JRPP Reference No.	2010SYW027
Development Application No.	DA-1133/2010
Proposed development	Multi denominational lawn cemetery and associated works
Address	Lot 1 DP 599308 321 Greendale Road, Greendale
Applicant	Farah Georges
Land Owner	Peter Georgopoulos

1. EXECUTIVE SUMMARY

Figure 3: Site Plan for DA-1133/2010

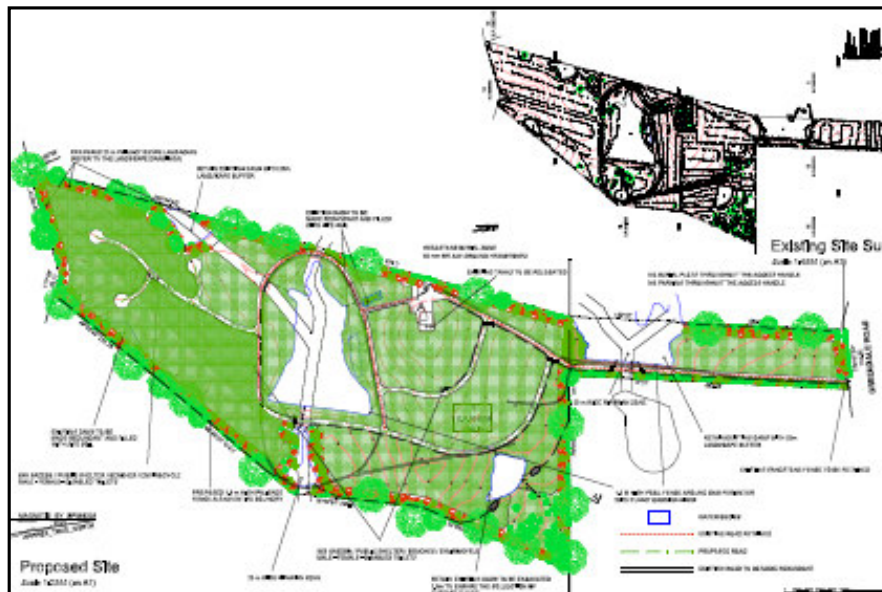
The amended site plan illustrates that the first 500 metres of the site to the first dam will not to be used for burials in response to reducing any visual impacts on the locality and the wider locality. The amended site plan illustrates that the rest of the site will be dedicated to lawn burials. No above ground burials in crypts or memorial walls for ashes are proposed. This arrangement and style of cemetery has been chosen to minimise the visual impact of the development on the view from Greendale Road and from neighbouring properties and thus maintain the appearance of a rural landscape. A copy of the site plan is illustrated in Figure 3 below.

As illustrated in the site plan a 20 metre wide landscaped buffer is to be provided around the perimeter of the whole site. The site contains a number of dams that will be removed, with the two larger dams being retained and remodeled into landscape features.

Figure 4: Burial Plot calculation

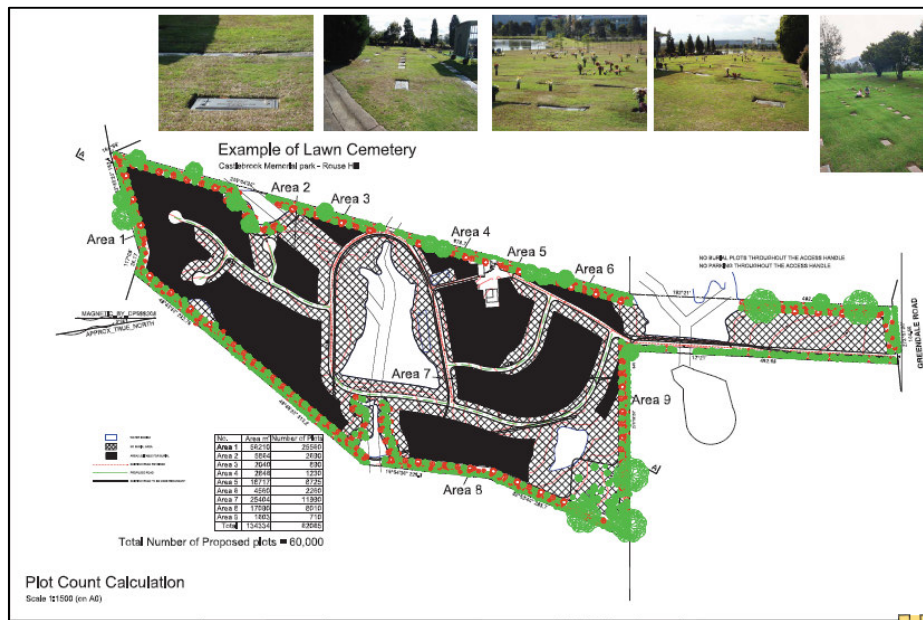
The burial plot diagrams originally supplied with the application are indicative and do not show dimensions for the width of the burial plots. The also show a separation distance between each plot. The objections have used scaled dimensions for width to calculate a yield. The objectors' calculations are accurate for the assumptions made.

The applicant in response to these concerns has provided a burial plot layout for the whole site. A total of 62,065 burial lots have been plotted, although permission is sought only for 60,000 plots. A denser plot layout has been provided with reduced provision of pathways and the removal of separation distance between plots.
